## RESOLUTION NO. CR-16-20

### A RESOLUTION TO APPROVE THE DEVELOPMENT PLAN FOR FARMSTEAD SUB AREA H LOCATED AT 62 JACKSON PIKE

## ITEM 5: 202003040010 – Farmstead Subarea H (Development Plan)

**Subject: Farmstead Sub-Area H - Final Development Plan**

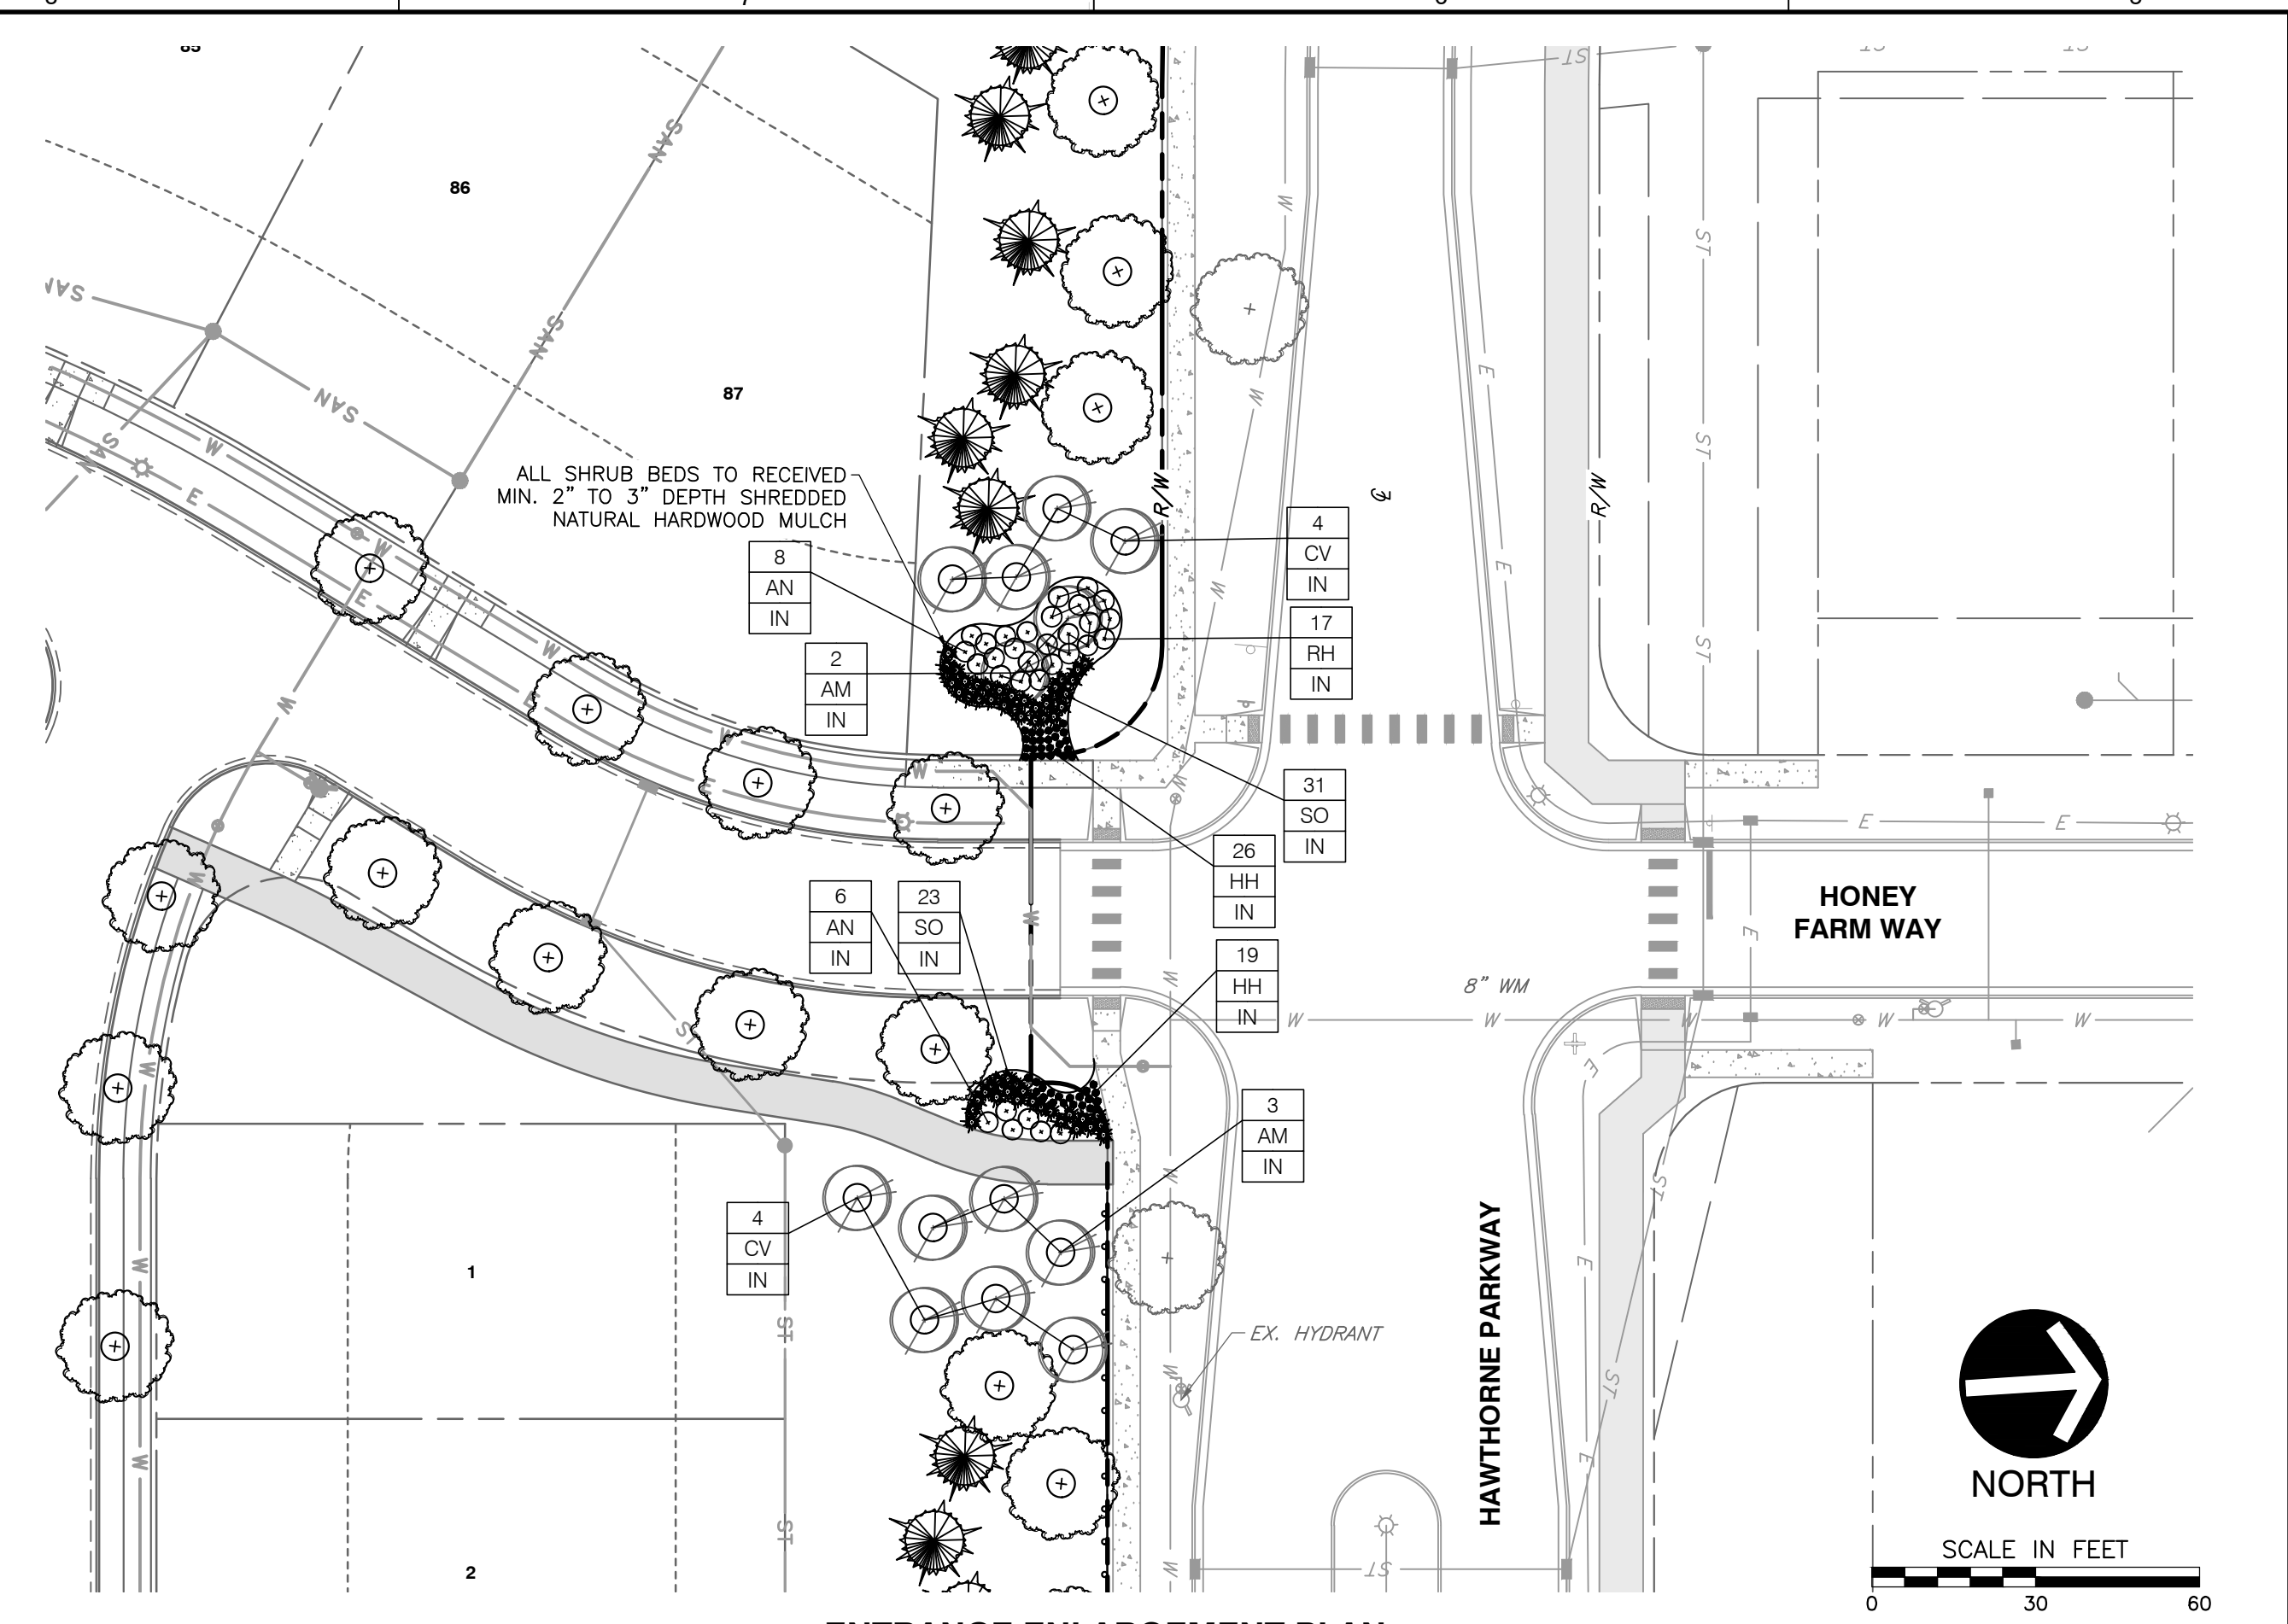
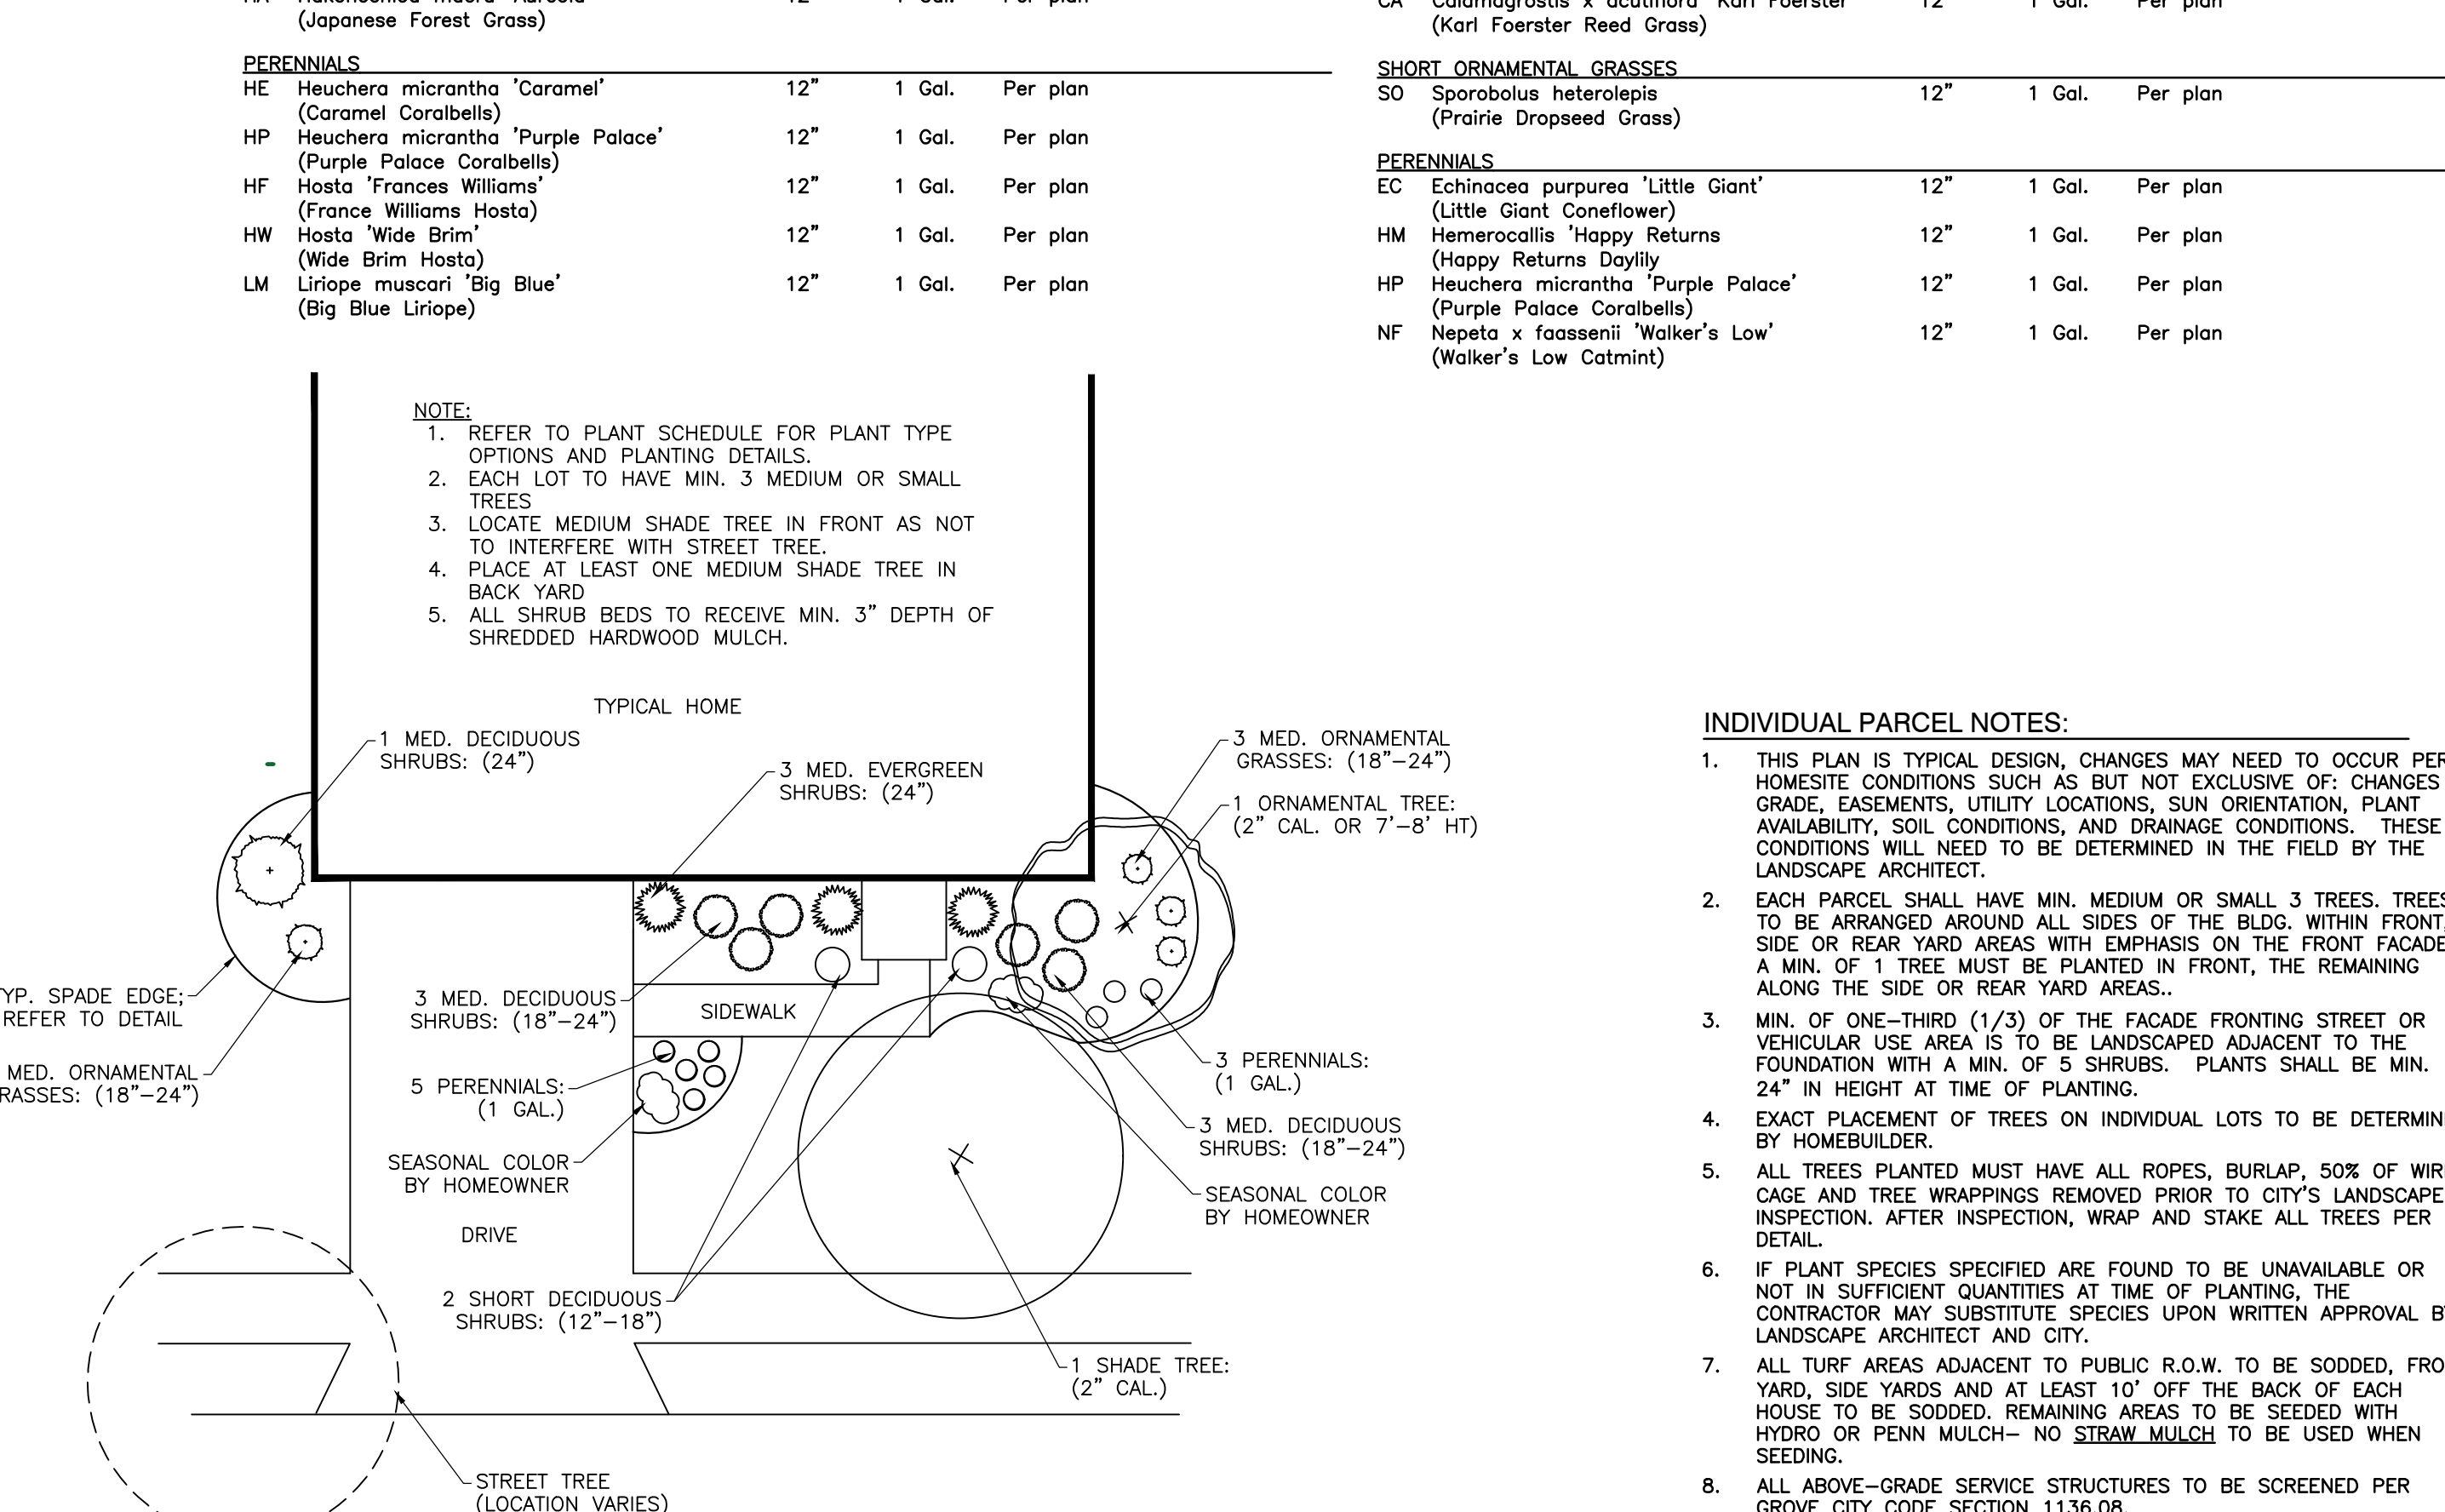
**This will be protected by silt fence once construction documents are produced.**
7. Tree Planting Typical on page C701 still states that 4" (inches) of shredded bark mulch is to be used. This should be corrected to state 2-3" (inches).

**All details have been updated; Refer to sheet C701**
8. Please provide a landscaping detail for landscaping that will be provided around the base of each CBU.

**A typical detail for the CBU has been added on sheet C701, and is consistent with the Farmstead Development.**
9. An updated version of Note #1 of Individual Parcel Note still requires correction. Pages C700 and C702 are not consistent, as note #1 for The Individual Parcel notes; page C702 lists as #2.
